From: Mark Simmons <[Mark.Simmons@north-herts.gov.uk](mailto:Mark.Simmons@north-herts.gov.uk)>  
Sent: 30 May 2025 12:10  
To: Melissa Tyler <[Melissa.Tyler@north-herts.gov.uk](mailto:Melissa.Tyler@north-herts.gov.uk)>  
Subject: 4 x DOC's re: 23 High Street, Royston, Hertfordshire, SG8 9AB  
Importance: High

**25/01018/DOC - Details of Condition : Details reserved by Condition 2 (Rooflights) of listed building consent reference 24/02501/LBC granted on 03.04.2025.**

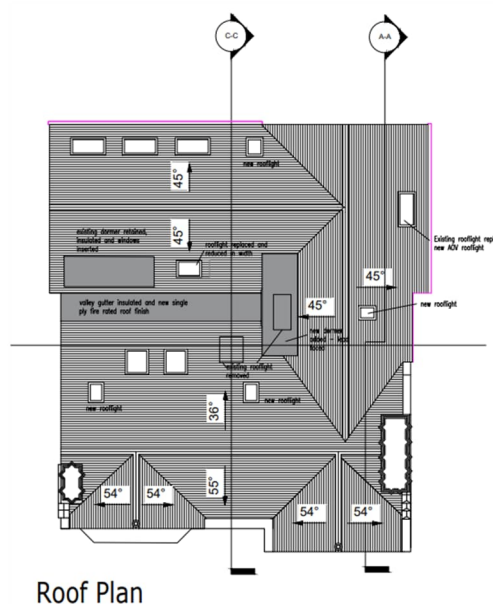
According to approved proposed roof plan drawing no. PL03 (extract below), there are 5no existing roof lights, 4no. new roof lights and 2no. replacement roof lights. It is noted that all new rooflights are to be flush Velux GGL 3070 / CK01 / Centre-pivot / Pine. Normally on listed building work I would be seeking 'conservation type' roof lights but considering the existing situation I don't think I can sustain a robust objection to the proposed roof lights so I raise **NO OBJECTION**.

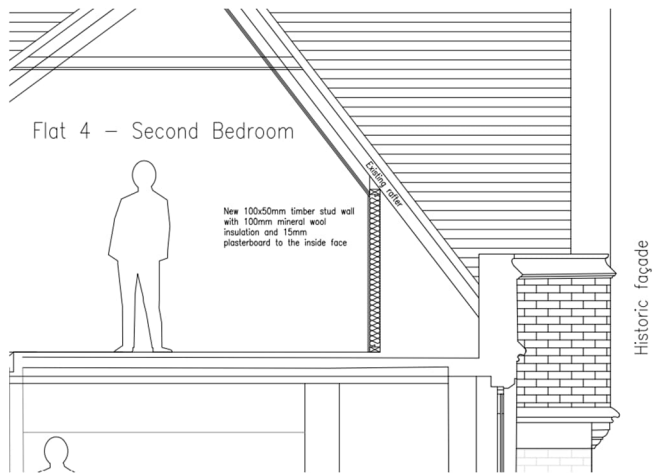
The submitted Method Statement states: *The original leadlight windows to the front elevation will only be cleaned with a soft detergent. The internal stone frames will be gently rubbed down and repainted. All adjacent internal & external walls to the leadlight windows are not being touched, only redecorated internally.*

This I find **ACCEPTABLE**.
